# Unanswered questions

The 6 months allotted for the examination of Riveroak's DCO is almost complete and what has been glaringly obvious is Freudmann and his colleagues have treated the whole DCO process with disdain.

We now have the unedifying spectacle of a 4<sup>th</sup> set of questions detailing unresolved issues with only 2 weeks to go.

Fig 1

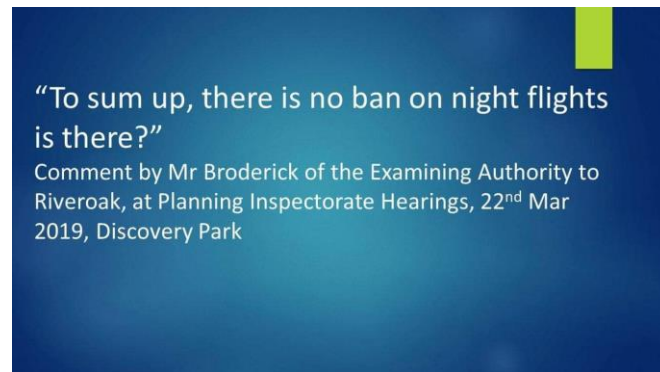
In essence HEMA flights (in red) are normally excluded at all airport's QC that leaves just late-arriving the issue and having a QC only operating between 6-7am for those passenger flights planning to leave using up the 2000 QC then that leaves "late-arriving cargo flights" unfettered access to Manston because they would not incur a penalty and seeing as the airport operator determines late or otherwise the losers would be those trying to sleep. It is also clear that RSP has resisted having a cap limiting flights at night preferring the flexibility of a QC.

Fig 7

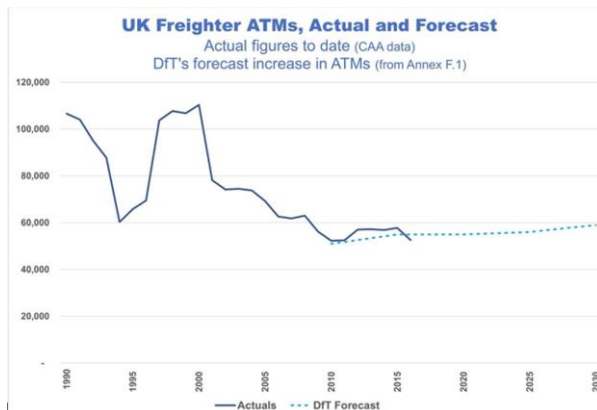
Even if it could be considered a Cargo “Hub” every job created at Manston would simply be a transfer from another airport as Cargo ATM’s have flatlined over the last 10 years (fig 7) showing no sign of a recovery
